**TOWN OF OCEAN RIDGE
PLANNING & ZONING REGULAR MEETING
AGENDA**

**May 19, 2026 at 9:00 AM
Town Hall - Meeting Chambers**

To:	Planning & Zoning Board Members
From:	Corey O’Gorman, Town Planner
Meeting Date:	May 19, 2026
Subject:	7 Harbour Dr N – Development Plan Review

**PLAN REVIEW REPORT
5920 N Ocean Boulevard
05/06/2026**

DRAINAGE PLAN

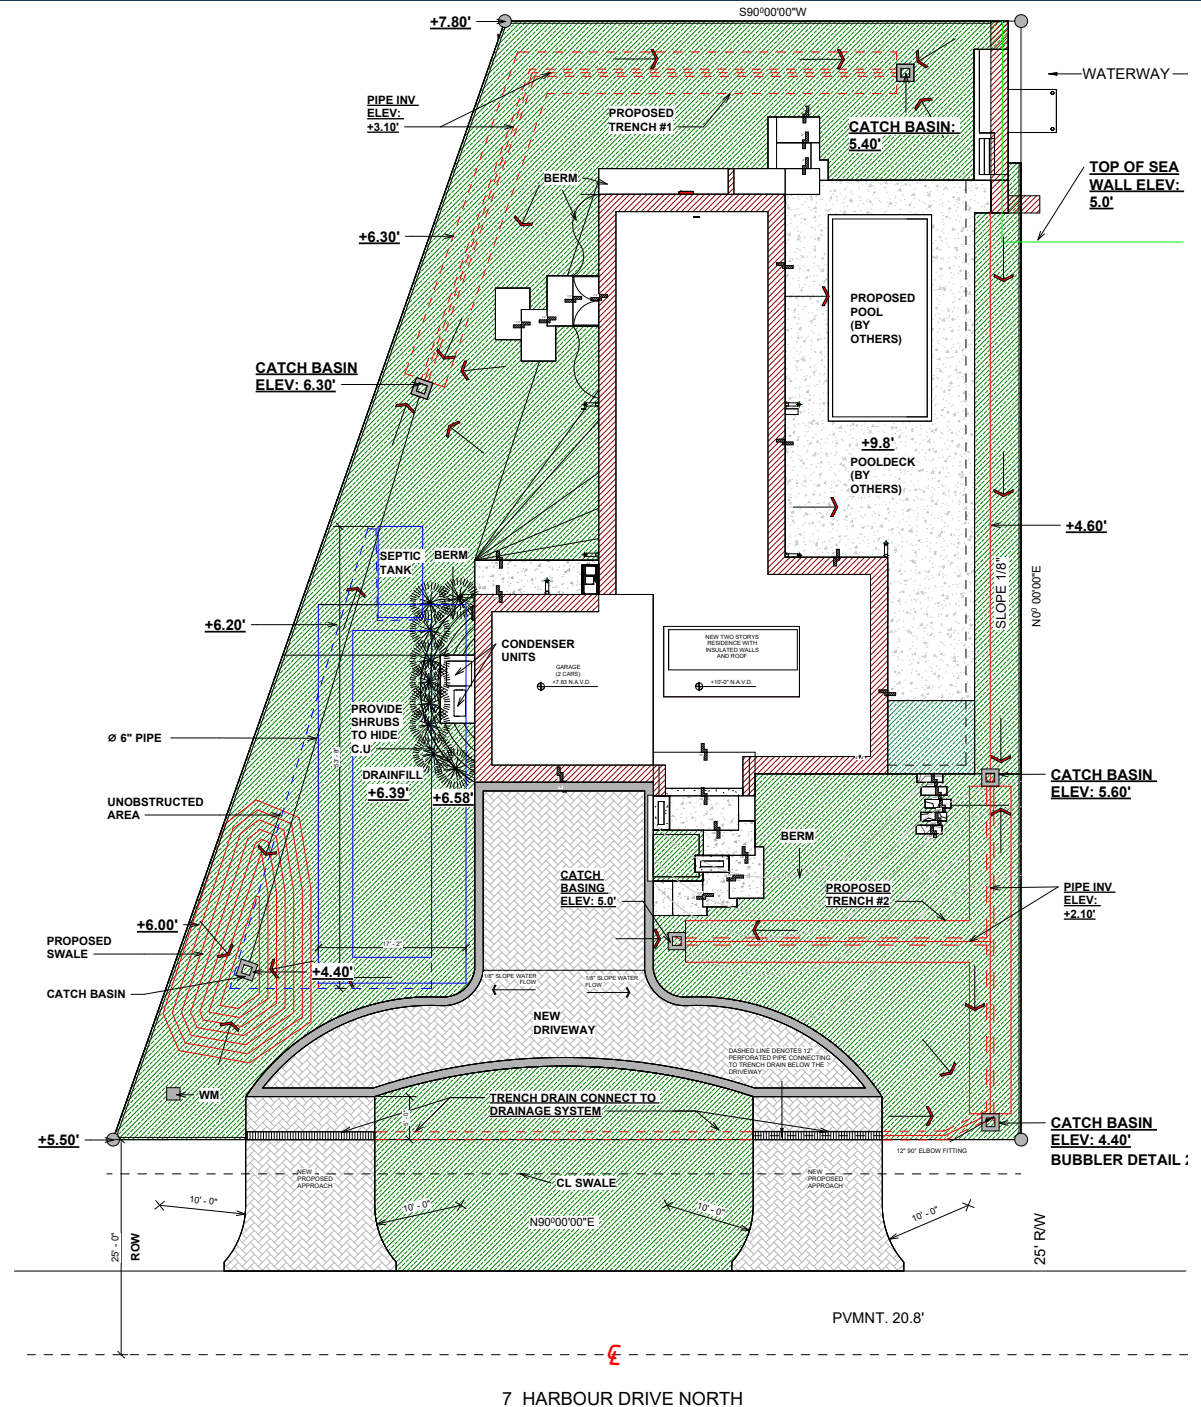
Based on questions from the Board to the applicant and discussion by the Board, action on the application was continued to request that the applicant address: 1. How the drainage will work and that water will not run-off to the neighboring property to the west; 2. That the air conditioning units are adequately screened from view; 3. That the graphic be provided showing the proposed house in relationship to other homes in the neighborhood; and, 4. The applicant consider adding contrast on the building elevations to address the stark appearance. Town Staff recommends approval subject to review of the revisions by the Planning and Zoning Board in accordance with Section 63-56 for Development Plan Review.

The proposed drainage system has been designed to effectively manage stormwater through a series of coordinated strategies across the site.

The system primarily operates through two main trench drains, which collect, control, and retain water within the property through appropriate drainage systems. This approach ensures that stormwater is contained on-site and does not run off toward the front of the lot, but instead is properly managed across all areas of the property.

In addition, a trench drain is incorporated at the driveway to assist in capturing and evacuating surface runoff in this area, preventing water accumulation and improving overall site performance.

Red arrows shown on the plan indicate the direction of water flow throughout the property, providing a clear representation of how stormwater is conveyed across the site.

Special consideration has been given to prevent any discharge of water onto neighboring or adjacent properties, maintaining compliance with local regulations and protecting surrounding sites.

Sheet: ground floor plan

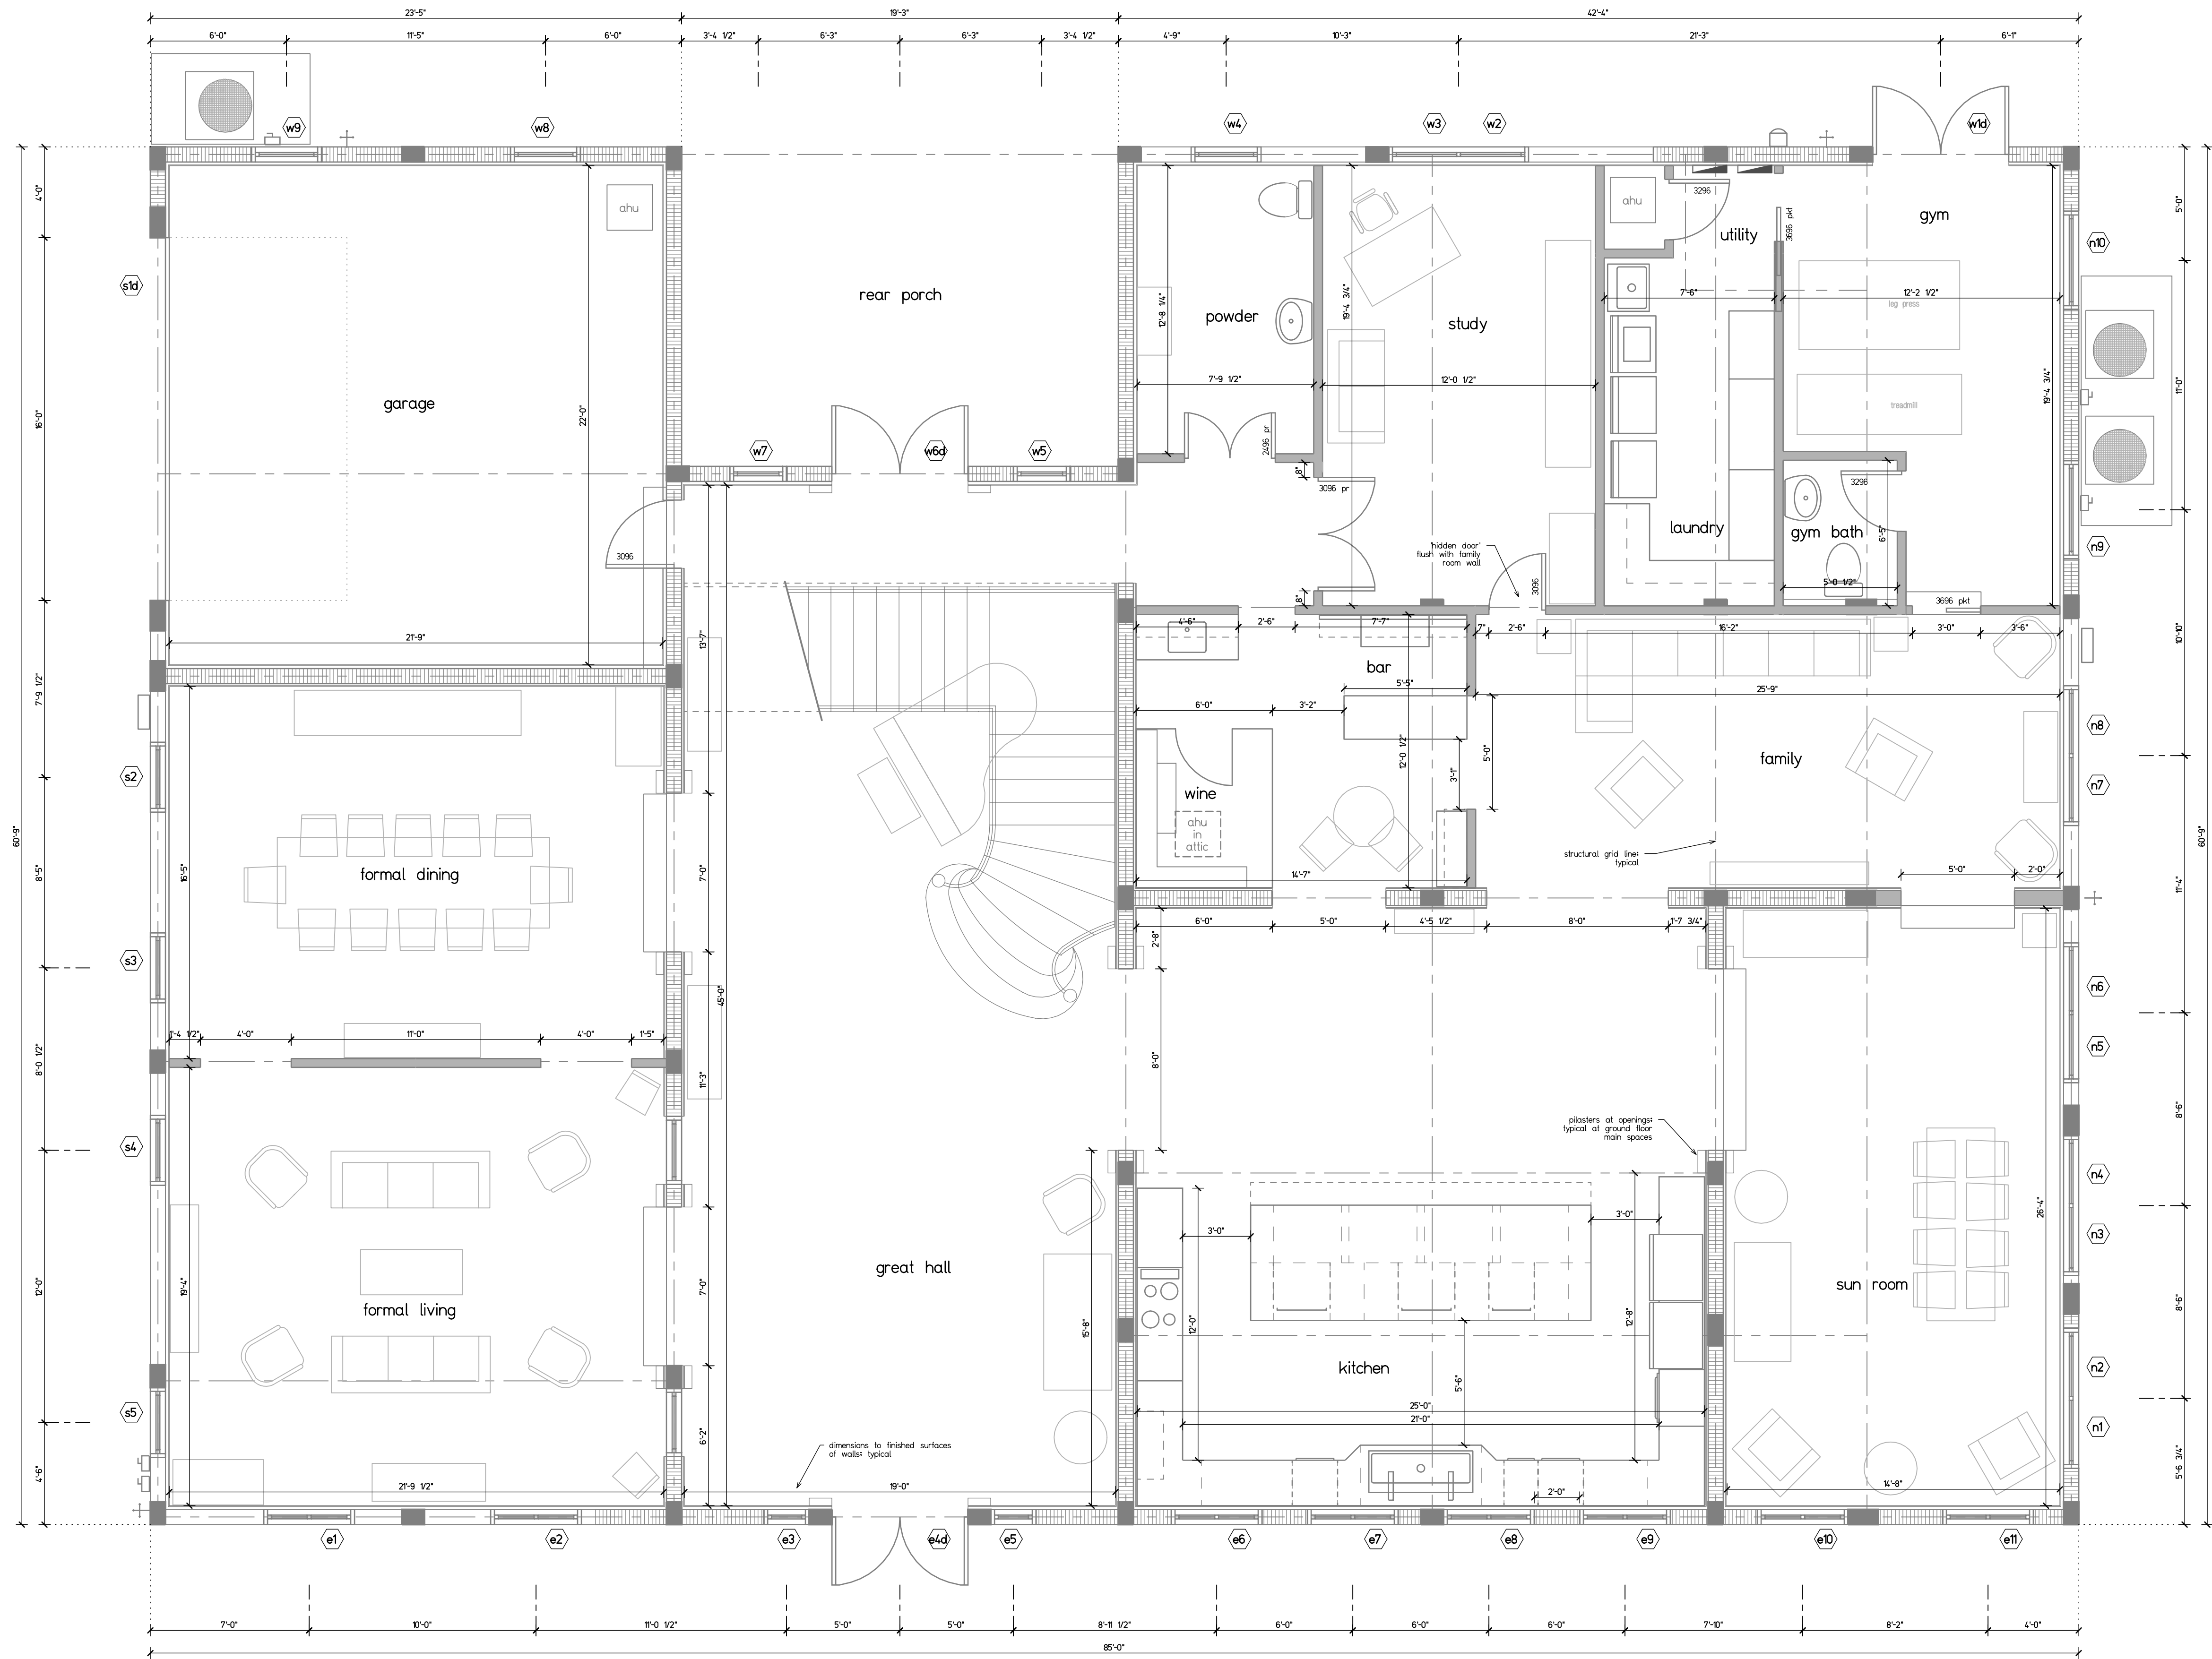
Comment: Please revise sheet A05 to show two parking spaces dimensioned at 10 x 20.
